# Value Engineering

FINAL REPORT

Chicago Ditch Dam Rehabilitation

DATE: December 23, 1996

Figure 8. Sheet Pile and Riprap Diversion Dam

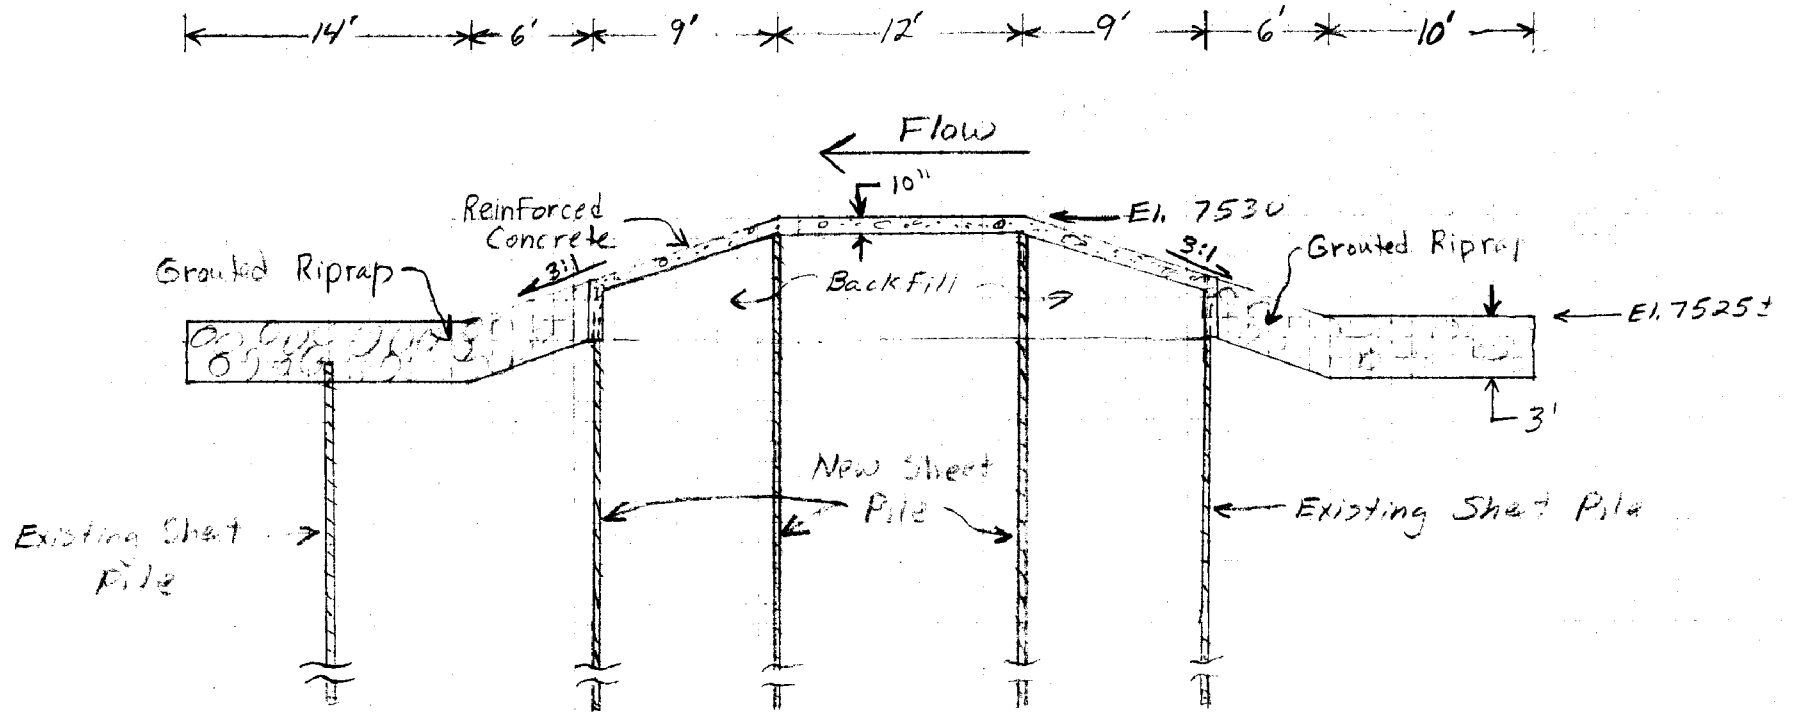
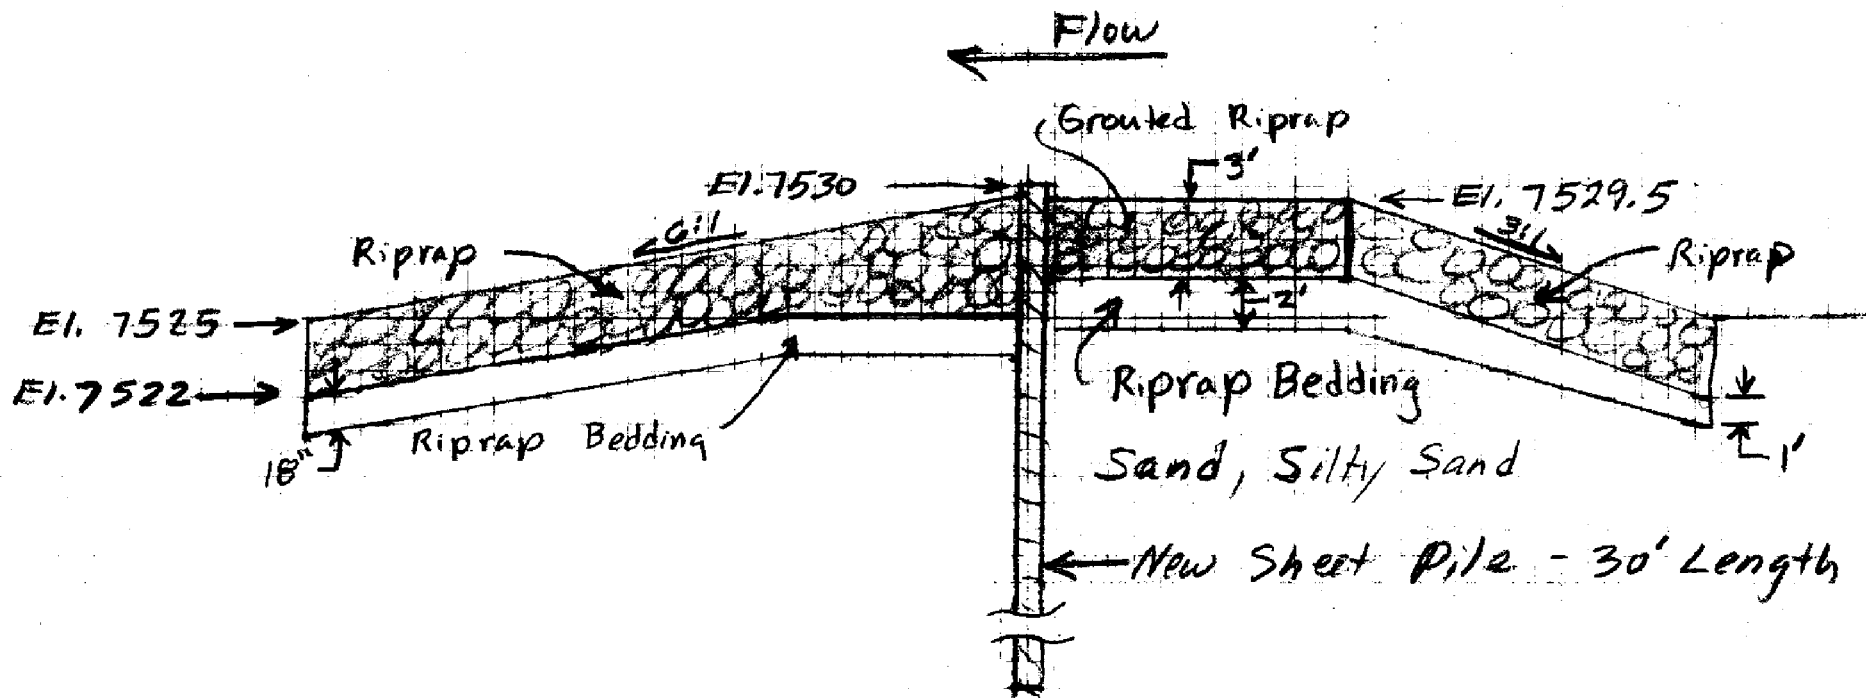
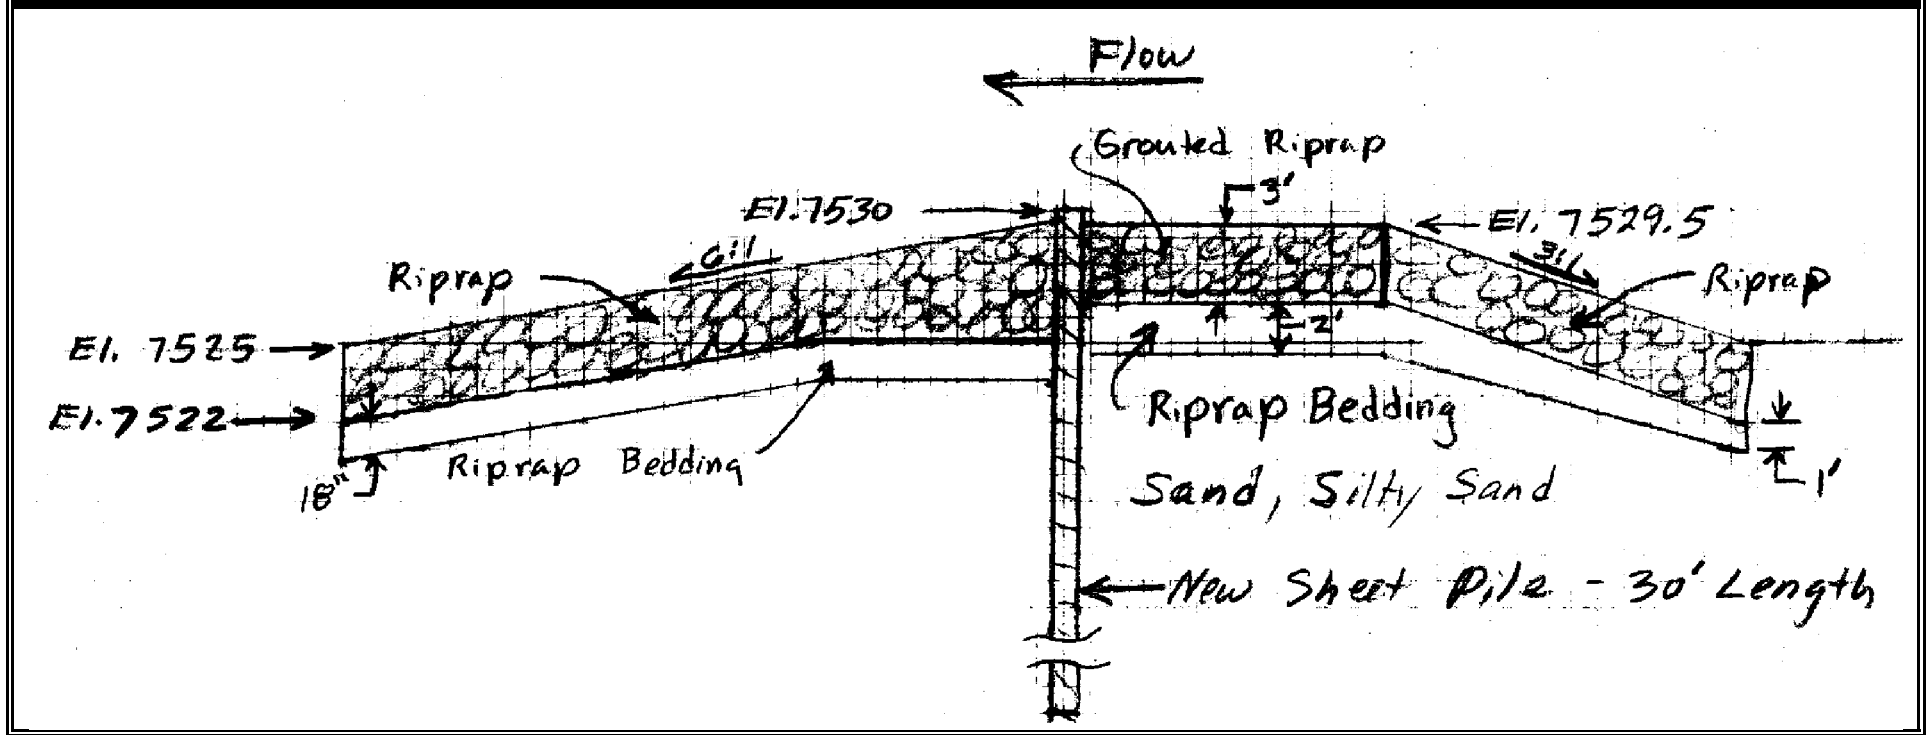
<b>PROJECT:</b> Chicago Ditch Dam Rehabilitation	
<b>COMPONENT:</b> Diversion Dam	<b>FUNCTION:</b> Divert Water
<b>ALTERNATIVE DESCRIPTION</b>	
<p>Construct a single row of sheet pile with riprap protection to serve as the diversion dam. The primary features of this alternative proposal are:</p> <ol style="list-style-type: none"> <li>1) A single row of sheet pile would extend across the river to form the sill of the trapezoidal section. The top elevation of the sheet pile would be Elevation 7530 (same as the crest of the Title I concept). This elevation is about 5 feet above the stream bed. The sheet piles would extend about 25 feet into the foundation to about Elevation 7500.</li> <li>2) UngROUTED riprap would be placed at a 6 to 1 slope on the downstream side of the sheet pile. A 12-foot wide riprap berm would be located on the upstream side of the sheet pile to provide access for maintenance. The upper part of the berm would be grouted to create a surface that is smoother than ungrouted riprap. This would allow access by maintenance vehicles. The upstream slope of the berm would be ungrouted riprap with a 3 to 1 slope.</li> </ol>

<b>BENEFITS</b>	<b>DISADVANTAGES</b>
<p>Since construction should proceed faster, it should reduce the water diversion downtime for the Refuge.</p> <p>Construction can occur during winter months.</p> <p>The amount of dewatering effort required would be less extensive.</p>	<p>The crest will not be as smooth as concrete and will make walking and driving a little more difficult.</p> <p>The roughness of the upstream face will make it more difficult to remove smaller sized debris.</p> <p>Additional investigation into condition of existing sheet pile would be necessary.</p>
<b>IDENTIFIED RISKS:</b>	
<p>If removal of smaller debris is required, it may become lodged in rough surface and necessitate more effort.</p> <p>This option will tie into existing sheetpile in a method similar to the Title I design. If the investigation determines that the present condition of the existing sheetpile is unsuitable for the proposed use, a new sheetpile wall costing about \$120,000 would be necessary.</p>

<b>PROJECT:</b> Chicago Ditch Dam Rehabilitation		
<b>COMPONENT:</b> Diversion Dam	<b>FUNCTION:</b> Divert Water	
<b>ORIGINAL CONCEPT</b>	<b>VALUE STUDY CONCEPT</b>	
<p>Construct a trapezoidal dam section with a reinforced concrete crest.</p> <p>Install three new rows of sheet piles and tie into concrete.</p>	<p>Construct a trapezoidal section with riprap.</p> <p>Install one new row of sheet pile at crest.</p> <p>Grout the crest of the dam to facilitate movement of maintenance equipment and staff over the crest.</p>	
<b>COST ITEMS</b>	<b>NONRECURRING</b>	<b>LIFE CYCLE</b>
ORIGINAL CONCEPT	\$ 1,221,800	
VALUE CONCEPT (-)	\$ 893,000	
SAVINGS	\$ 328,800	
NUMBER OF UNITS (X)	1	
TOTAL SAVINGS	\$ 328,800	
VALUE STUDY COSTS (-)	\$ 20,000	
IMPLEMENTATION COSTS (-)	\$ 0	
<b>NET SAVINGS</b>	<b>\$ 308,800</b>

Figure 10. Roller Compacted Concrete Diversion Dam

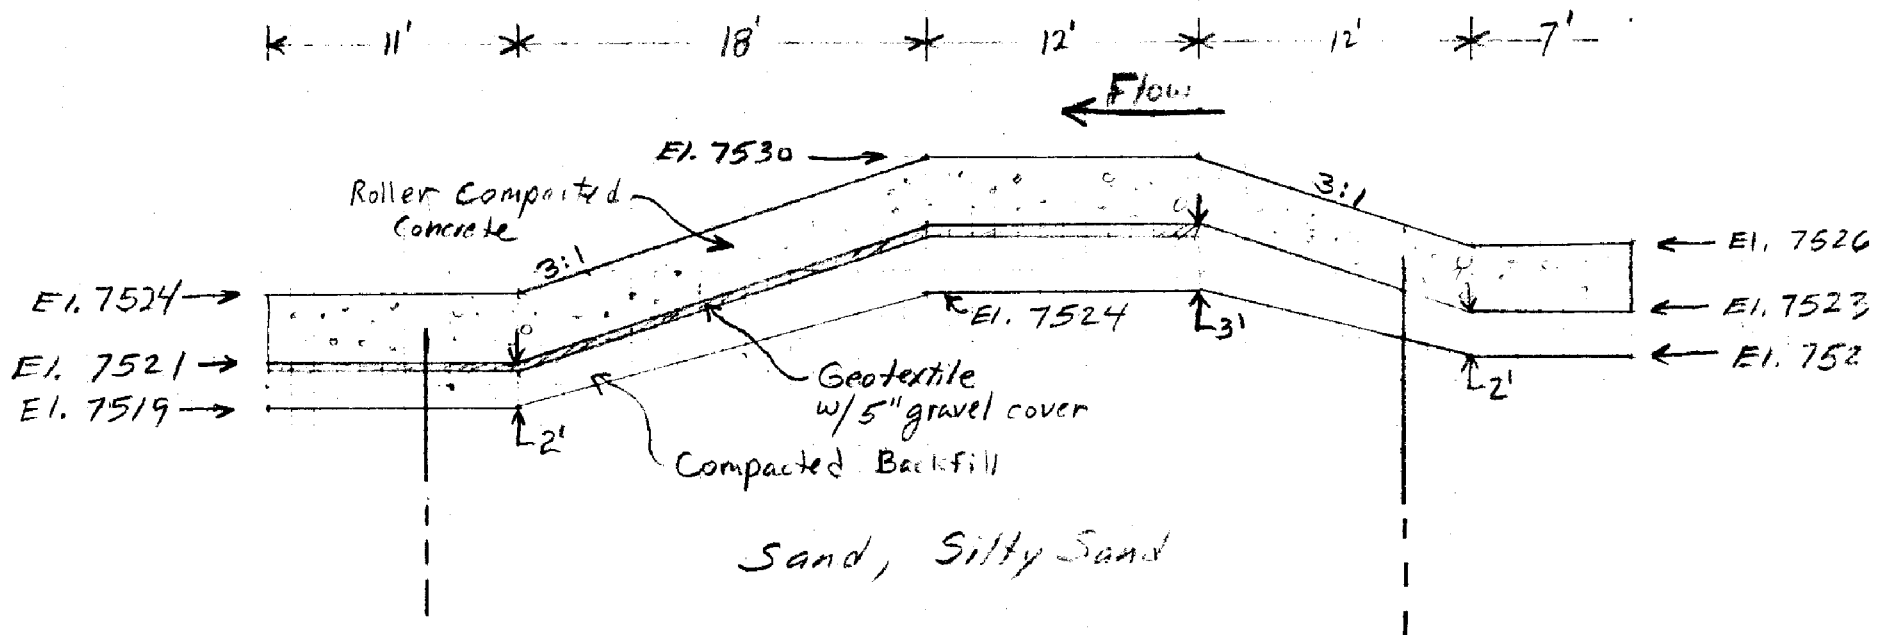
<b>PROJECT:</b> Chicago Ditch Dam Rehabilitation	
<b>COMPONENT:</b> Diversion Dam	<b>FUNCTION:</b> Divert Water
<b>ALTERNATIVE DESCRIPTION</b>	
<p>Construct the crest and slopes of the diversion dam with roller compacted concrete. The sheet piles and reinforced concrete would be eliminated. The primary features of this alternative are:</p> <ol style="list-style-type: none"> <li>1) A 3-foot layer of roller compacted concrete would form the crest and slopes of the diversion dam. The dimensions of the structure would be the same as that described in the Title I concept. A 12-foot crest width and 3 to 1 slopes. The roller compacted concrete would tie into the existing two rows of sheet piles. At an additional cost (not included in proposal estimate), the lifts could be formed to allow a relatively smooth series of lift faces.</li> <li>2) The geotextile would be placed under the crest and downstream portion of the roller compacted concrete to provide filter protection in the event that cracks form in the concrete.</li> </ol>

<b>BENEFITS</b>	<b>DISADVANTAGES</b>
<p>Construction (although not as simple as Alternative 1A) will be faster than the original proposal. Therefore, some operational time would be saved.</p>	<p>Roller compacted lifts may ravel which leaves an less attractive appearance, as compared to a reinforced concrete surface.</p> <p>If lifts are not formed, small debris may accumulate on lift faces.</p>
<b>IDENTIFIED RISKS:</b>	
None noted.

<b>PROJECT:</b> Chicago Ditch Dam Rehabilitation		
<b>COMPONENT:</b> Diversion Dam	<b>FUNCTION:</b> Divert Water	
<b>ORIGINAL CONCEPT</b>	<b>VALUE STUDY CONCEPT</b>	
<p>Construct a trapezoidal dam section with a reinforced concrete crest.</p> <p>Install three new rows of sheet piles and tie into concrete.</p>	<p>Construct a trapezoidal section with a roller compacted concrete crest.</p> <p>Tie in concrete slopes to existing sheet piles.</p>	
<b>COST ITEMS</b>	<b>NONRECURRING</b>	<b>LIFE CYCLE</b>
ORIGINAL CONCEPT	\$1,221,800	
VALUE CONCEPT (-)	\$ 708,700	
SAVINGS	\$ 513,100	
NUMBER OF UNITS (X)	1	
TOTAL SAVINGS	\$ 513,100	
VALUE STUDY COSTS (-)	\$ 20,000	
IMPLEMENTATION COSTS (-)	\$ 0	
<b>NET SAVINGS</b>	<b>\$ 493,100</b>

Figure 11. Grouted Riprap Diversion Dam

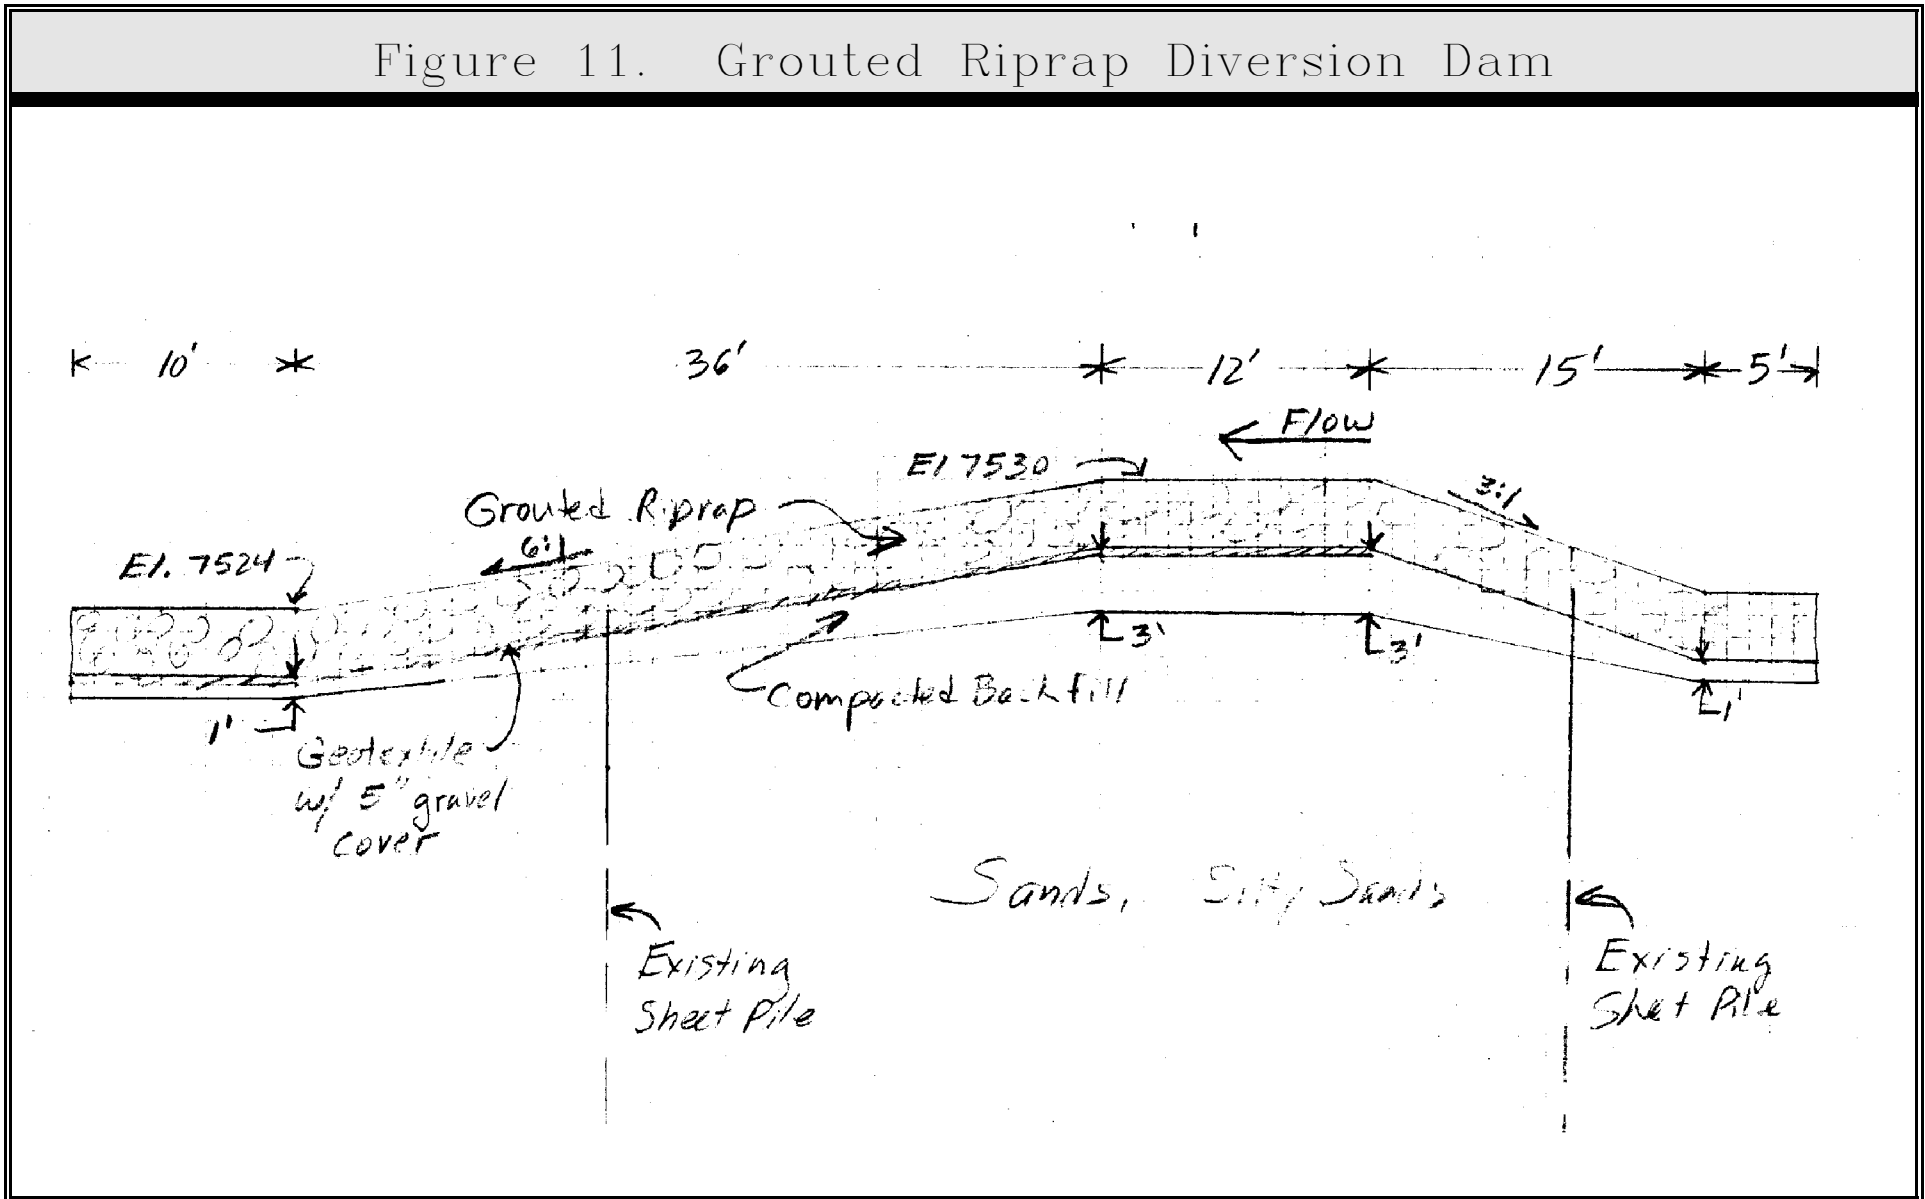
<b>PROJECT:</b> Chicago Ditch Dam Rehabilitation	
<b>COMPONENT:</b> Diversion Dam	<b>FUNCTION:</b> Divert Water
<b>ALTERNATIVE DESCRIPTION</b>	
<p>Construct the diversion dam crest and slopes using grouted riprap and eliminate the new sheet piles and reinforced concrete. The primary features of this alternative are:</p> <ol style="list-style-type: none"> <li>1) A 3-foot layer of grouted riprap would form the crest and slopes of the diversion dam. The crest would have a 12-foot width and the upstream slope would be 3 to 1. The downstream slope would be 6 to 1. The grouted riprap would tie into the existing two rows of sheet piles.</li> <li>2) A geotextile would be placed under the crest and downstream portion of the grouted riprap to provide filter protection in the event cracks form in the grouted riprap.</li> </ol>	
<b>BENEFITS</b>	<b>DISADVANTAGES</b>
<p>Construction (although not as simple as Alternative 1A) will be faster than the original proposal. Therefore, some operational time would be saved.</p>	<p>The crest would not be as smooth as the Title I proposal but will still be accessible to foot traffic and maintenance vehicles.</p> <p>The upstream face will have a rough surface. This may make removal of small debris more difficult.</p> <p>Additional investigation into condition of existing sheet pile would be necessary.</p>

<b>IDENTIFIED RISKS:</b>	
<p>If removal of smaller debris is required, it may become lodged in rough surface and necessitate more effort.</p> <p>This option will tie into existing sheetpile in a method similar to the Title I design. If the investigation determines that the present condition of the existing sheetpile is unsuitable for the proposed use, a new sheetpile wall costing about \$120,000 would be necessary.</p>

<b>PROJECT:</b> Chicago Ditch Dam Rehabilitation		
<b>COMPONENT:</b> Diversion Dam		<b>FUNCTION:</b> Divert Water
<b>ORIGINAL CONCEPT</b>		<b>VALUE STUDY CONCEPT</b>
Construct a trapezoidal dam section with a reinforced concrete crest.  Install three new rows of sheet piles and tie into concrete.		Construct a trapezoidal section with a grouted riprap crest  Tie in the slopes into the existing sheet piles.
<b>COST ITEMS</b>	<b>NONRECURRING</b>	<b>LIFE CYCLE</b>
ORIGINAL CONCEPT	\$1,221,800	
VALUE CONCEPT (-)	\$ 845,100	
SAVINGS	\$ 376,700	
NUMBER OF UNITS (X)	1	
TOTAL SAVINGS	\$ 376,700	
VALUE STUDY COSTS (-)	\$ 20,000	
IMPLEMENTATION COSTS (-)	\$ 0	
<b>NET SAVINGS</b>	<b>\$ 356,700</b>
